HONDA Service Bulletin

Applies To: 2000 Accord EX L4 – ALL (with cloth interior only)

SRS Indicator On With DTC 9-3 or Driver's Seat Belt Buckle Replacement (Supersedes 01-055, dated July 3, 2001)

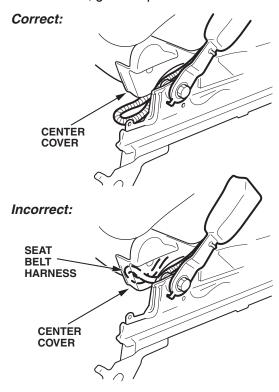
7. Remove the bracket cover.

- 8. Inspect the seat belt buckle harness at the rear inside corner of the seat rail near the area where the seat belt buckle is anchored to the seat frame.
 - If the harness is correctly routed outside the center cover, go to step 16.
 - If the harness is incorrectly routed inside the center cover, go to step 9.

- 12. To avoid distorting the center cover, remove it; then remove the seat belt buckle harness.
- Remove and discard the old seat belt buckle assembly.
- 14. Install the center cover.
- 15. Install the new seat belt buckle assembly, and carefully route the harness below and outside the center cover. Torque the center anchor bolt to 32 N·m (24 lb-ft).
